Access Compliance Report

Public Rights-of-Way

Intersection ID: 11357	Main Street: W_TRADE_ST	Cross Street: N_IRWIN_AV	Location:	E
ADA ID: D1E24AFEB32F	Ramp Type: Directional1	Initial Pass/Fail: Fail	Overall Compliance: No	Severity Score: 12.5

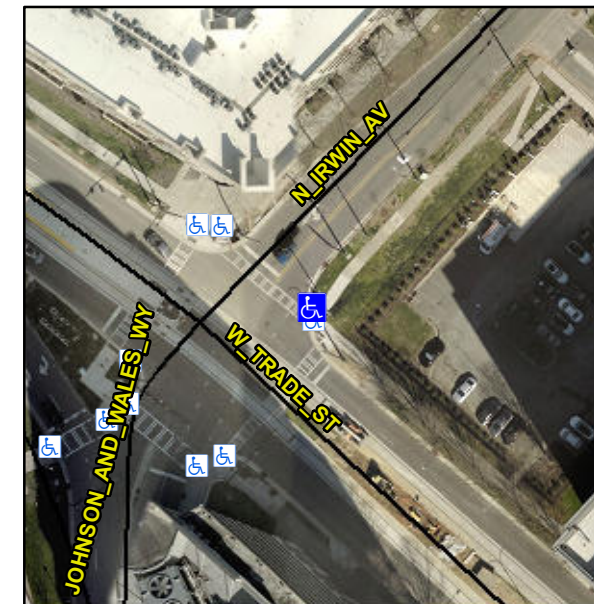
R304.2.2

Compliance	Description	Data	Compliance	Description	Data
N/A	Ramp Length (in)	88.0	N/A	Grade Break?	N/A
Yes	Ramp Width (in)	66.5	N/A	Grade Break Slope (%)	0.0
No	Ramp Slope (%)	8.8	N/A	Grade Break XSlope (%)	0.0
Yes	Ramp XSlope (%)	0.3			
N/A	Flare Type LT	N/A	N/A	Flare Type RT	N/A
N/A	Flare Slope LT (%)	N/A	N/A	Flare Slope RT (%)	0.0
N/A	Flare Traversable LT?	N/A	N/A	Flare Traversable RT?	N/A
N/A	Landing Length (in)	0.0	N/A	DWS Provided?	N/A
N/A	Landing Width (in)	0.0	N/A	DWS Contrast?	N/A
N/A	Landing Slope (%)	0.0	N/A	DWS Length (in)	N/A
N/A	Landing X Slope (%)	0.0	N/A	DWS Full Width?	N/A
N/A	Landing Curb? (Y/N)	N/A	N/A	DWS Offset LT (in)	N/A
N/A	Shared Landing?	N/A	N/A	DWS Offset RT (in)	N/A
N/A	Gutter Ponding?	0.0	N/A	Gutter Slope (%)	N/A
N/A	Gutter Lip Ht (in)	0.0	N/A	Gutter X Slope (%)	N/A
N/A	Painted X Walk1?	Yes		Road Slope (%)	2.6
	X Walk 1 Direction	To NW		Road X Slope (%)	0.3
	X Walk 1 Width (in)	54.0		Clear Space?	N/A

Remove & Replace Entire Ramp.
